Permit of Authorization to Construct an On-Site Sewage Facility Permit Valid For One Year From Date Issued

Permit Number: 118251
Issued This Date: 02/12/2025
This permit is hereby given to: Pearson & Margaret Dabney

RE: Residential Septic System @ 1046 Sparkman Dr, Boerne, TX 78006
(Permit # 118251)--**Spray set back variance request**

**Re: Pearson & Margaret Dabney
Silver Hills Unit 1 Lot 154
Application for Permit for Authorization to Construct an On-Site
Sewage Facility (OSSF)**

TITLE: OSSF Design
 SHEET:

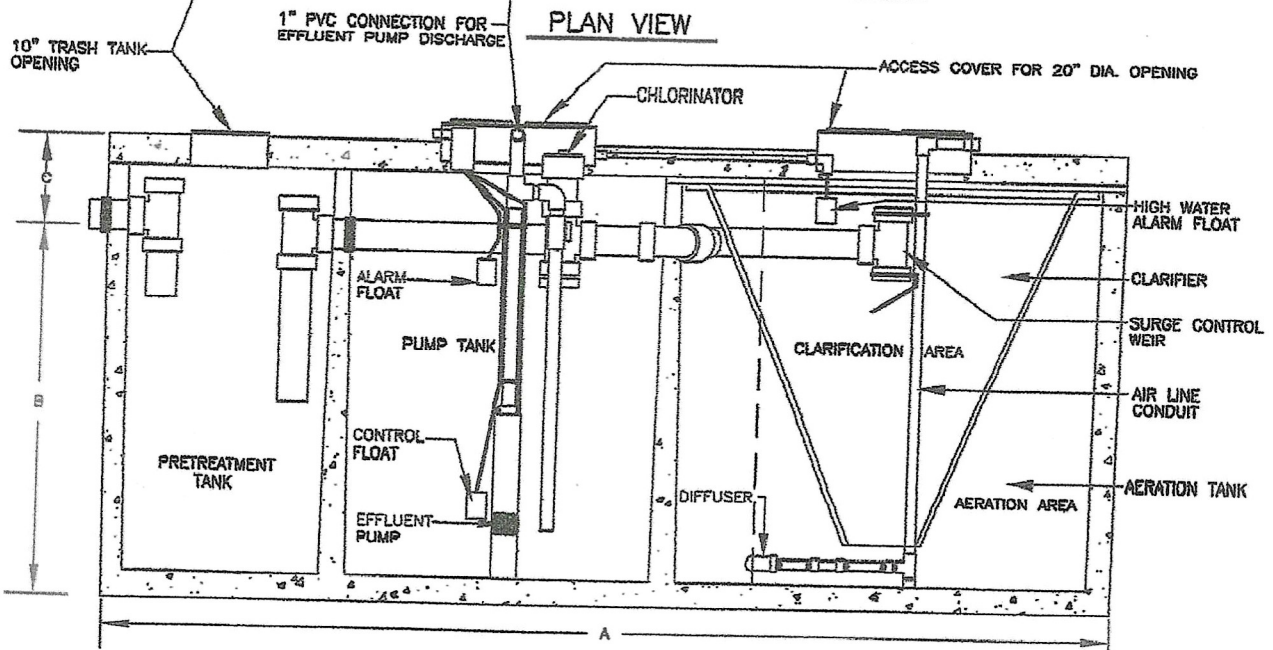
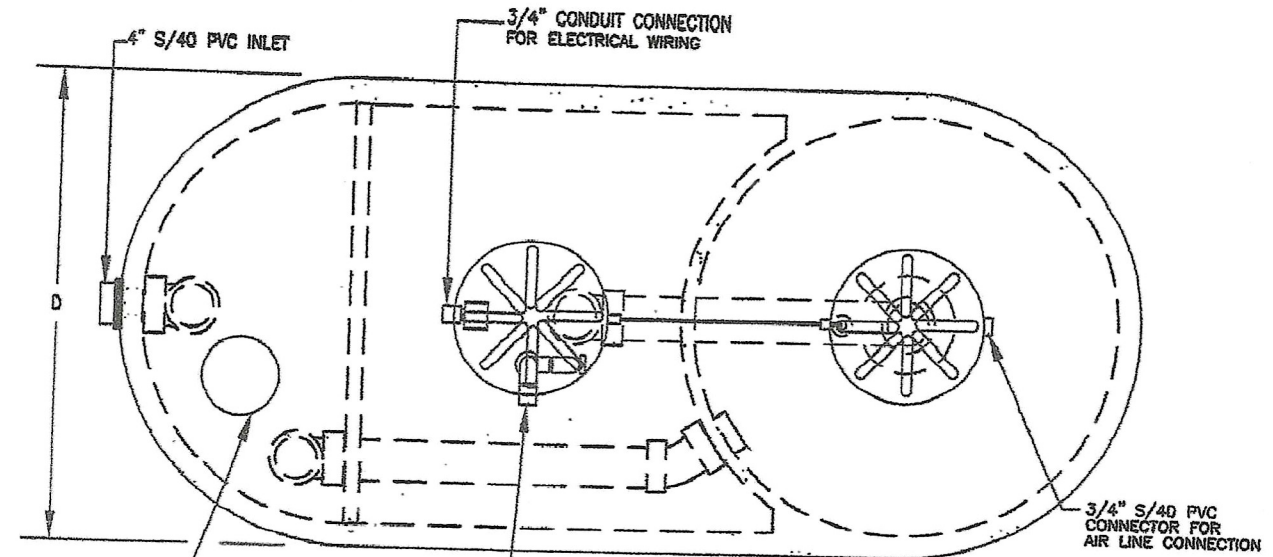
- ✓. **The owner name on the permit application must match the owner name as described on the recorded warranty deed.**
- ✓. **Both property owners must sign the permit application.**
- 3 ✓ **Maintain required 20 ft. setback from the edge of the spray areas to the property lines.**
4. **Revise as needed and resubmit.**

I am requesting a variance for the placement of the spray disposal area to be 10 feet from the property line. This variance is requested due to limited space and is in accordance with TCEQ rules Chapter 285 Table X, but is less than the 20' that Comal County regulations require.

Equivalent protection will be maintained by including a battery backup to the timer clock to assure that spray will only occur during predawn hours. In my professional opinion, this variance will not pose a threat to the environment or public health.
